CAPRICORN MUNICIPAL DEVELOPMENT GUIDELINES

2024 MEETING 8 MINUTES

Venue: Teams
Date and Time: 3rd October 2024 at 11:00 am

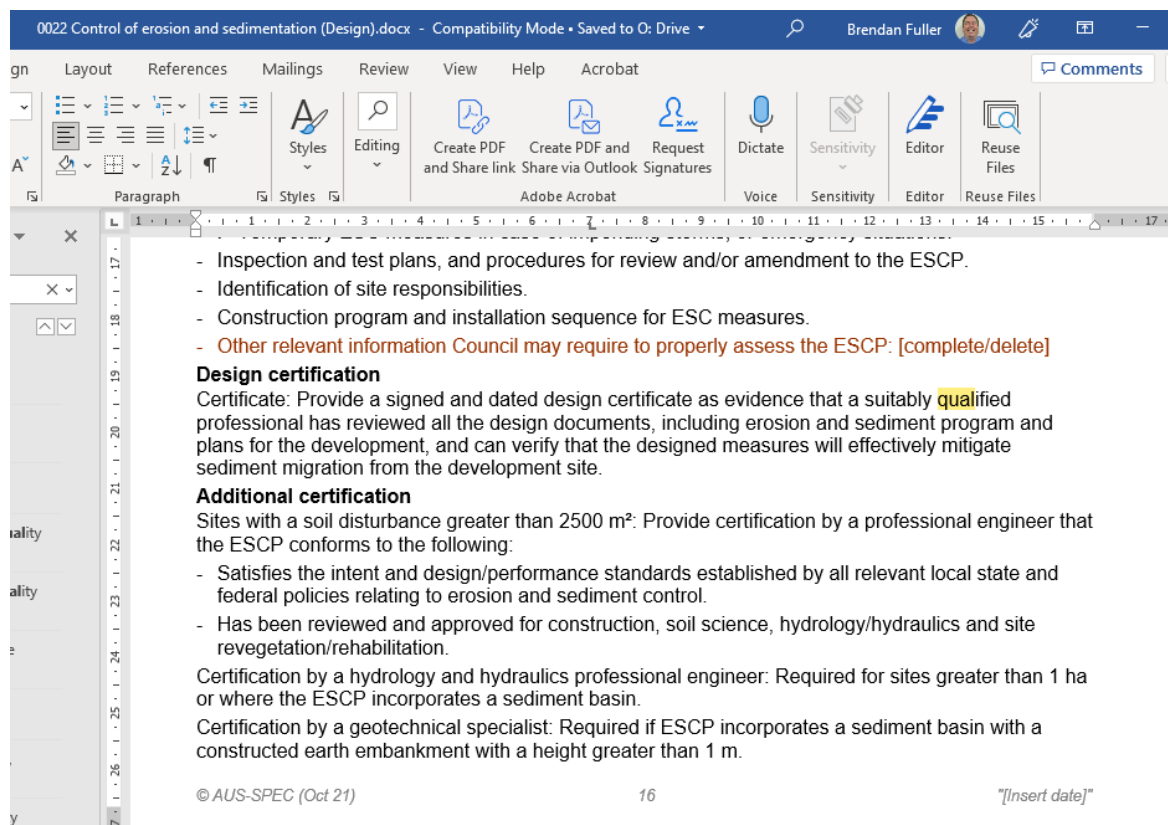
Preference with some LGAs remains raising 50mm dependent on suitability property side.

MCE to present 3 plan options within the next few weeks for review.

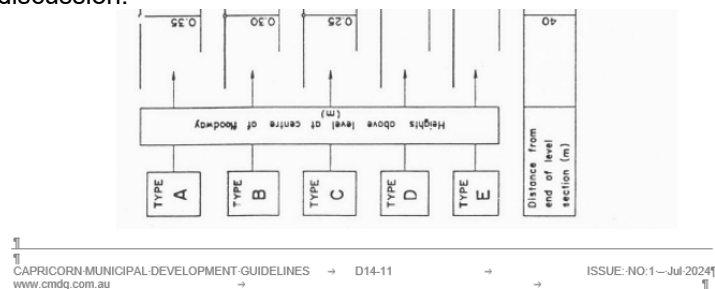
2. I understand that D14.01.05 has mentioned MUTCD. But I thought maybe better to have a bit more specified clauses related to the traffic signs related to a floodway? Such as "road subject to flooding" and the scale showing the flood depth.

Floodway signage has varying requirements depending on road environment. Section D14.10 includes some signage requirements at the floodway.

**FLOODWAY DESIGN**

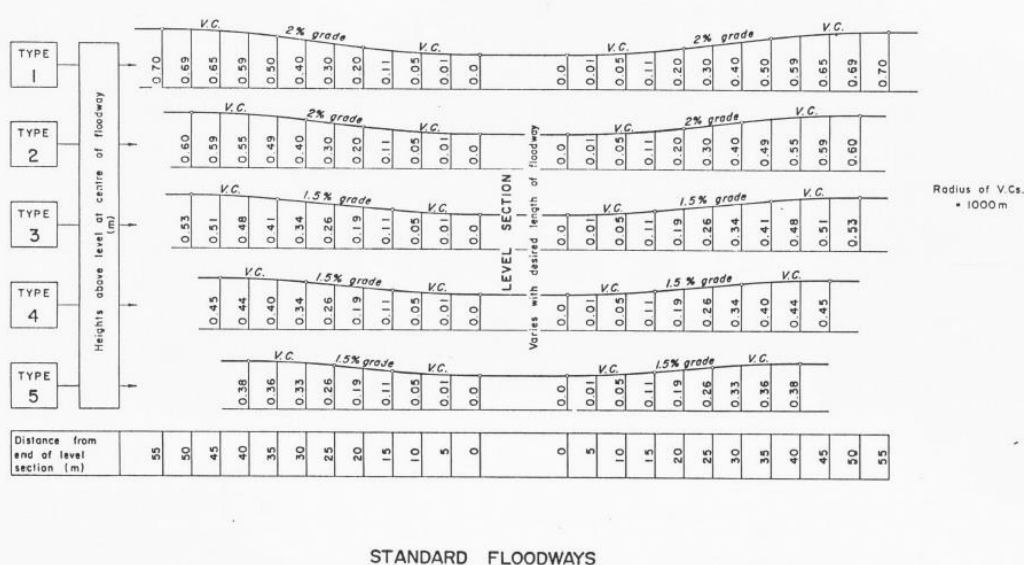
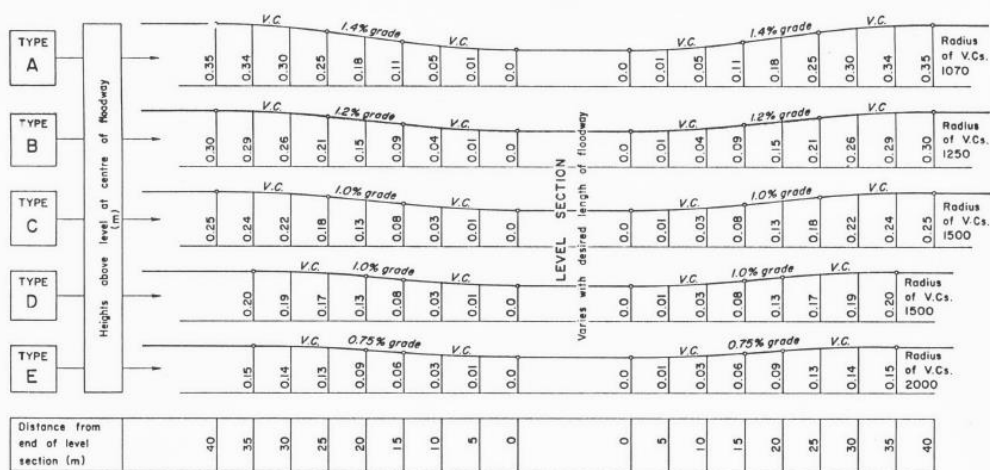
- D14.14.03 → The allowable dimensions of the following items are dependent on the waterway classification and site characteristics. **Dimensions**
- minimum width of the culvert array
 - minimum height of culvert
 - Invert level of the culvert relative to bed level
 - Obvert level of the culvert relative to bed level
 - Depth of cover over the culvert or stream bed

Refer to "Accepted development requirements for operational work that is constructing or raising waterway barrier works" — Section 5.1: New or replacement culvert crossings for guidance on acceptable culverts sizes.
